## VARGA TRAFFIC PLANNING Pty Ltd

### DA-2016/420 PROPOSED MIXED USE DEVELOPMENT 395-397 Princes Highway, Rockdale TRAFFIC AND PARKING MATTERS

## Response to Council's Parking and Traffic Comments dated 9 December 2016

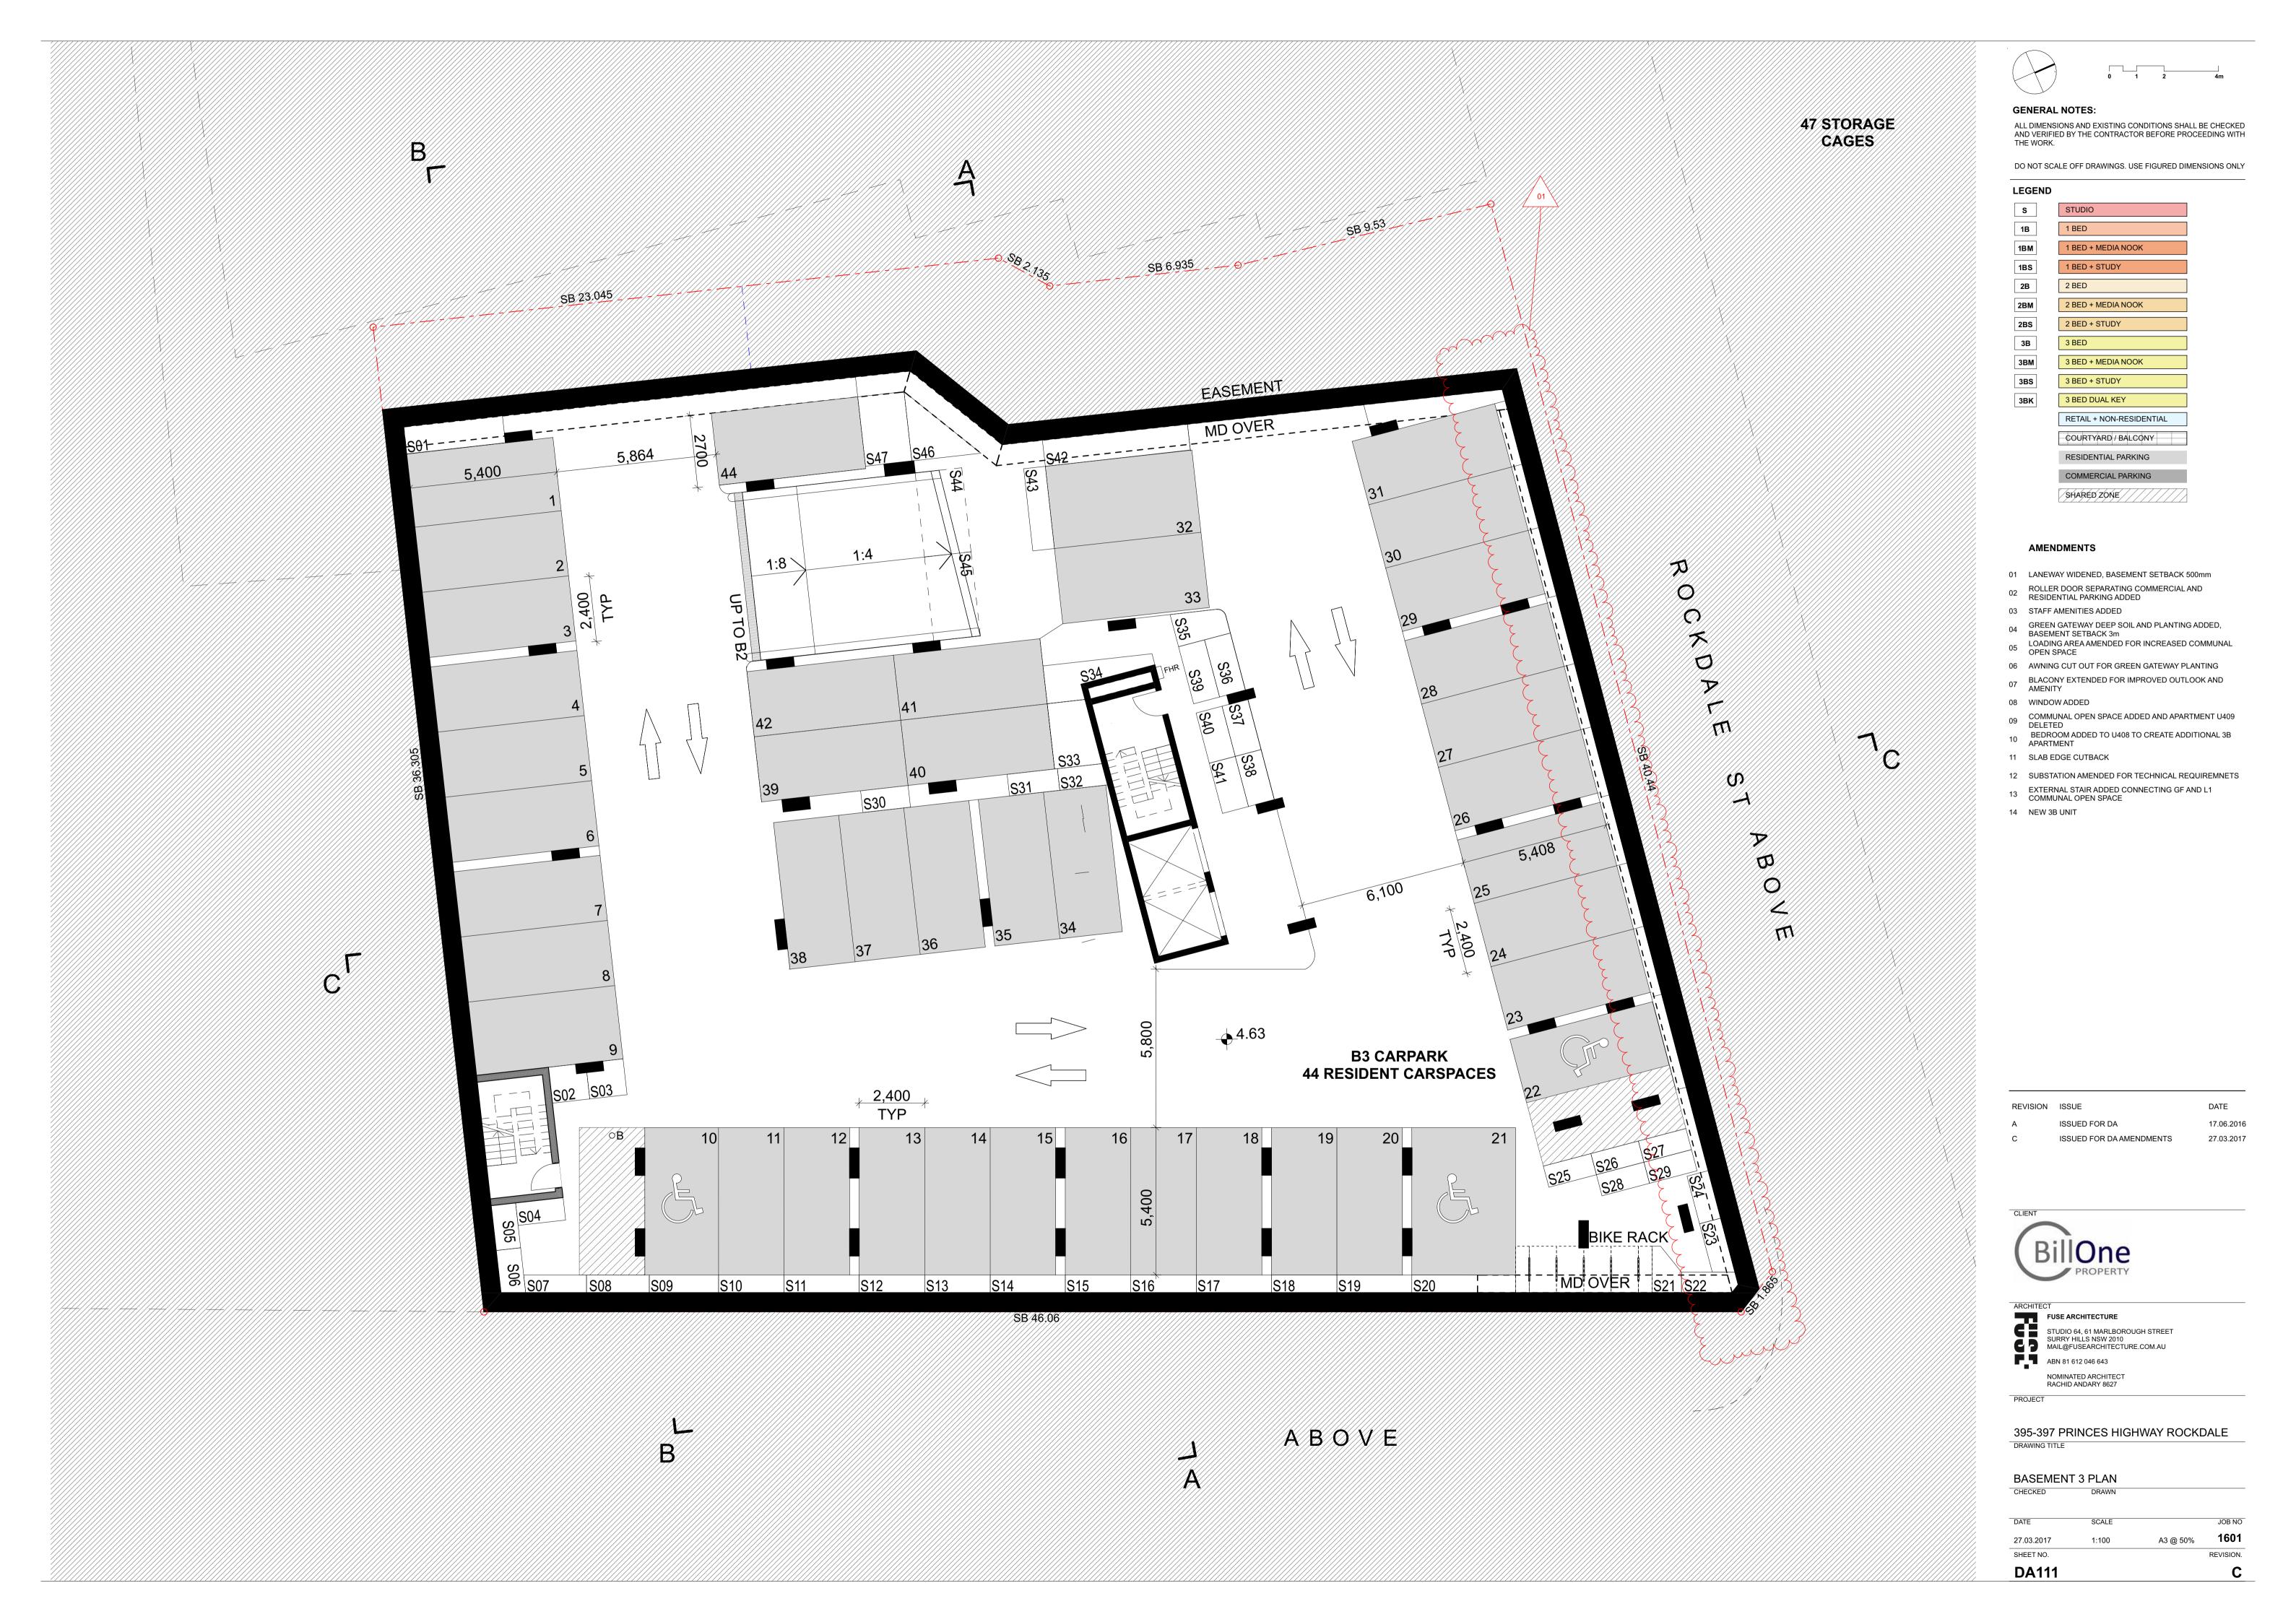
b. Traffic and Access	
(i) Waste Collection - in accordance with Councils Technical Specification - Waste Minimisation and Management (section 3.3), waste collection must be undertaken onsite. Therefore a 'Refuse Collection Vehicle' (RCV) sized loading bay shall be provided within the site.	The laneway is now proposed to be widened to 6.0m between kerbs and be dedicated to council.  The south-western kerb to the Highway will be modified to match the widened lane and allow better entry conditions from the Highway while retaining an adequate pedestrian environment.

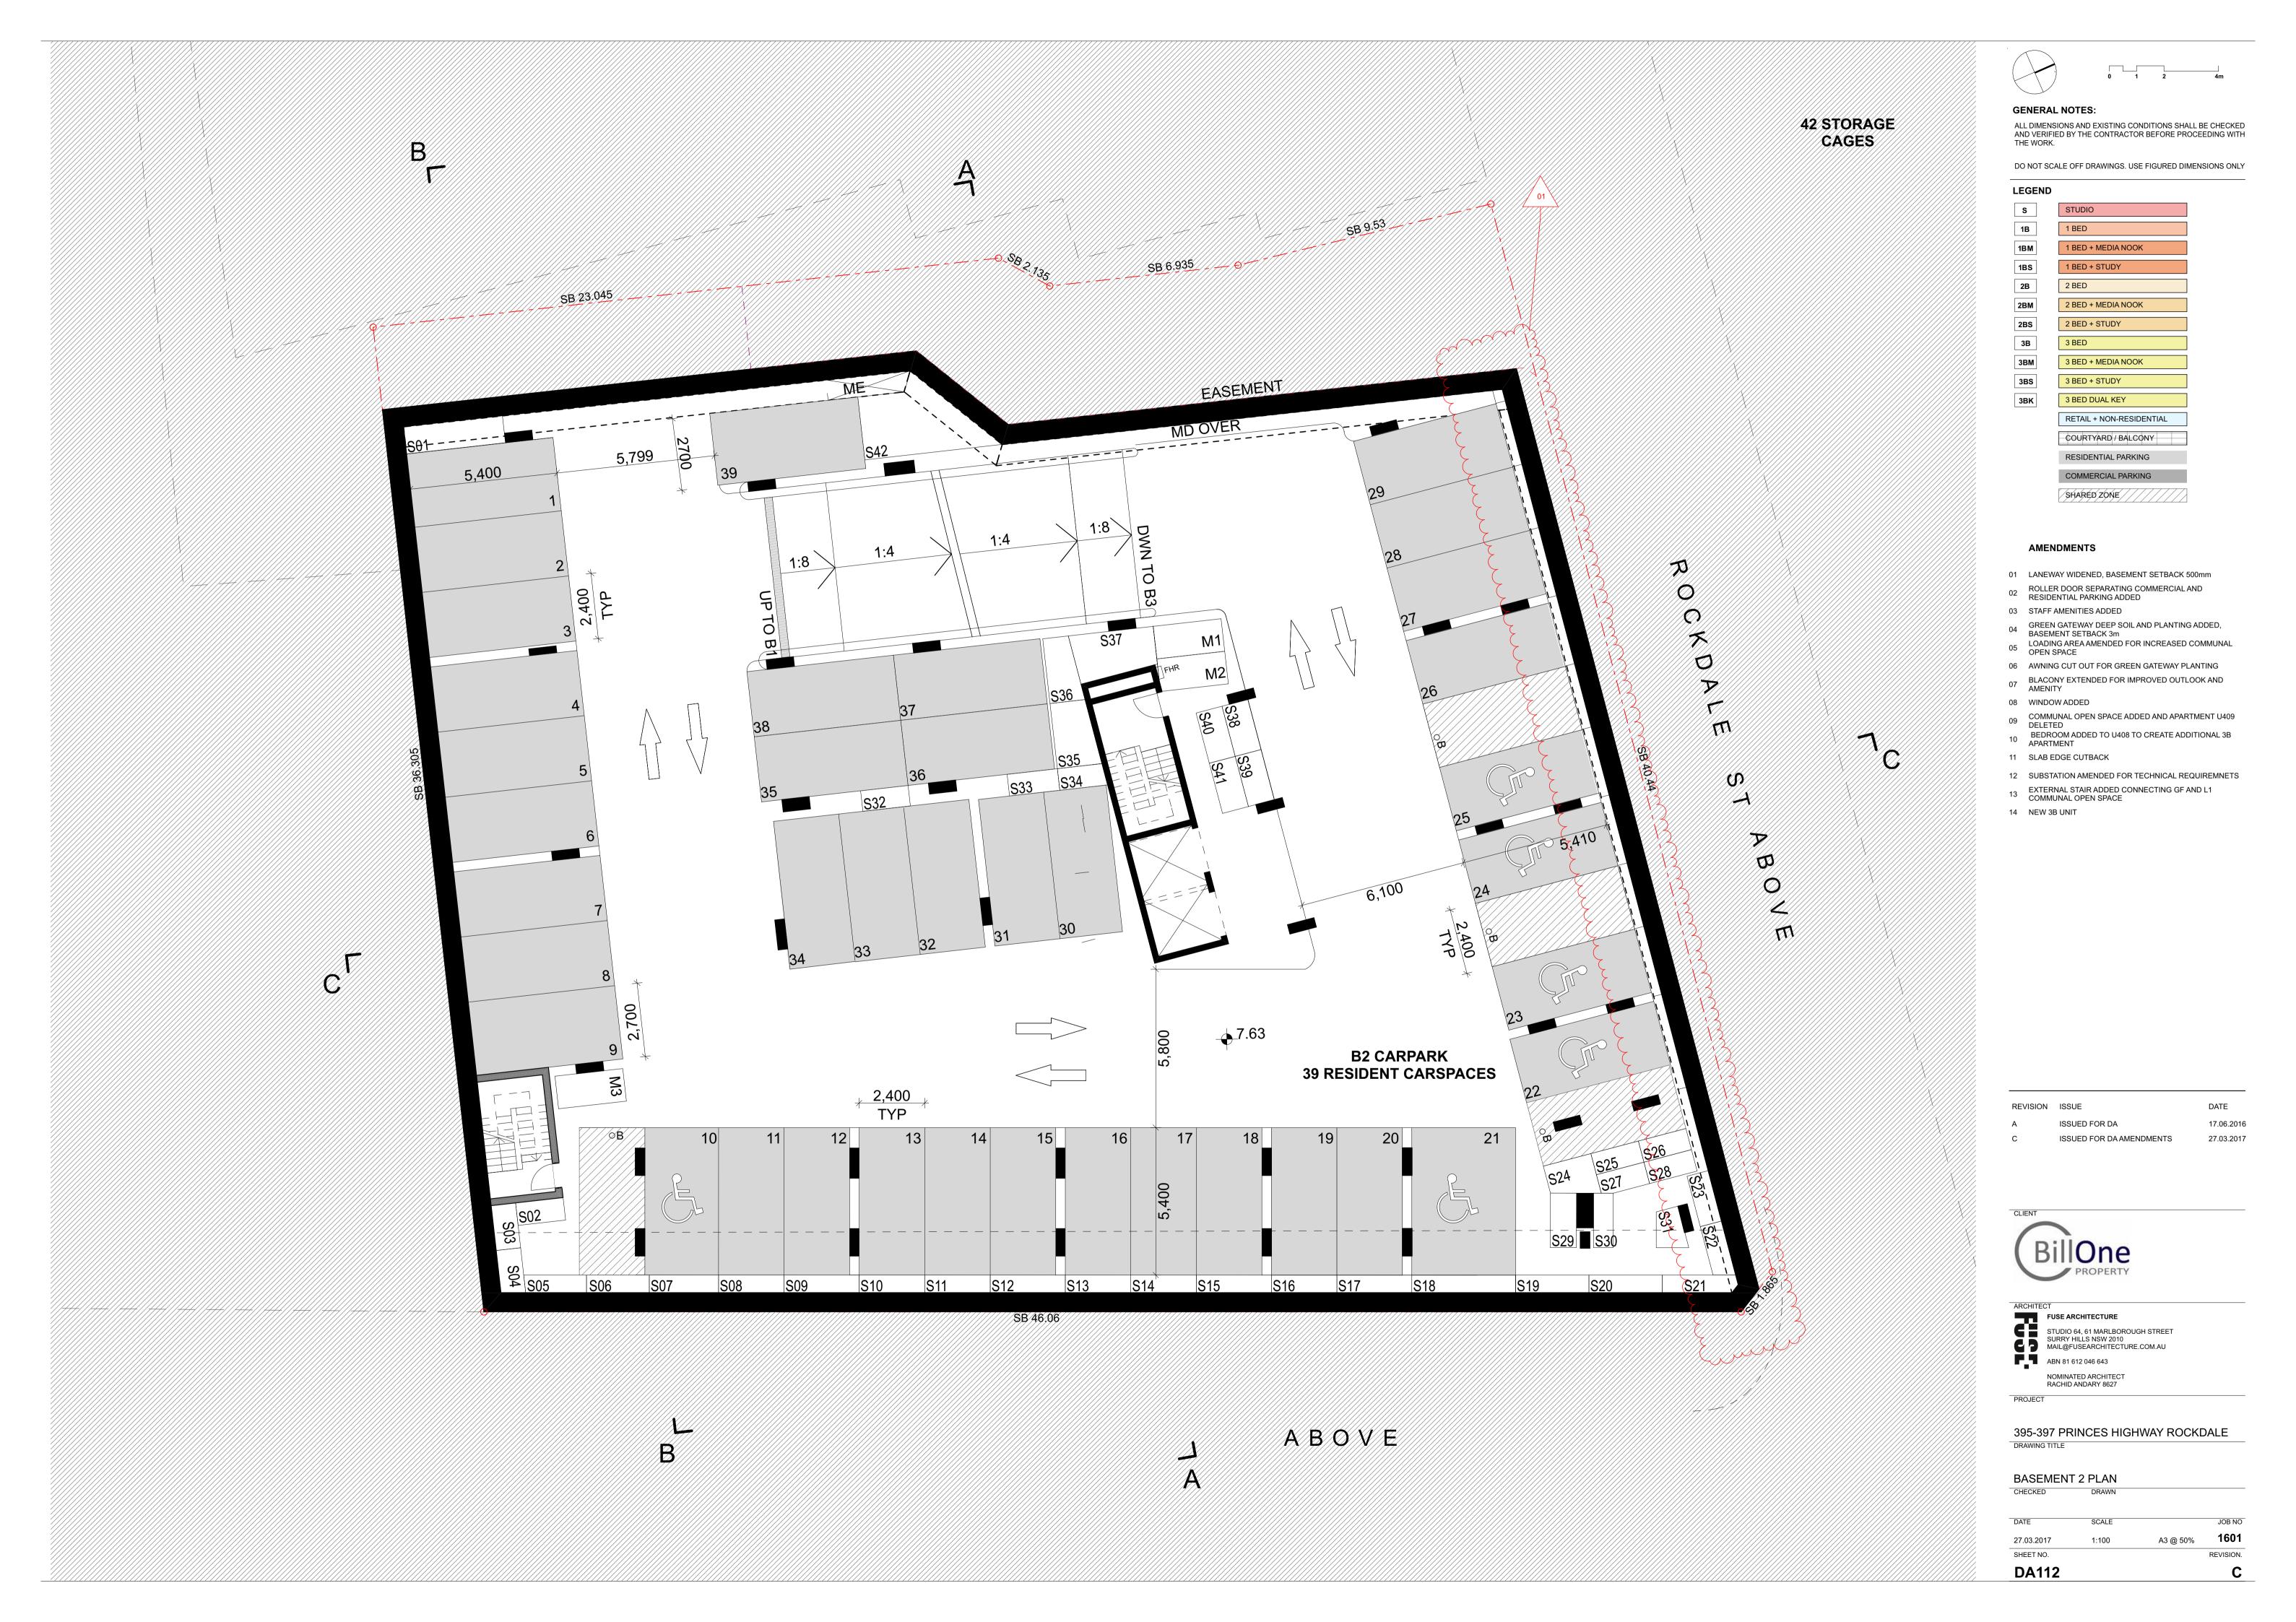
(iii)To ensure clear sight lines are provided for vehicles exiting the basement car park, the walls adjacent to the driveway access (including any associated gates) must be provided with a setback of 2.5m X 2m (or provided with an alternate treatment) at the property boundary.  (iv) In addition to RTDAC recommendations, a 3m X 3m corner splay is required to be dedicated to Council at the intersection of Unnamed Road and Princes Highway.  No structures are allowed above or below the footway easement area.	The architectural plans have been modified by setting the substation back 2.5m to provide required sight lines at the car park exit.  The site-line for provided cars is equivalent to a 3m spay while a smaller splay can be dedicated to Council in the subdivision of the lane widening.  However, dedication of a 3m splay would alter the configuration and appearance of the building to such an extent as to represent a major departure from the design competition process and a detrimental design outcome.
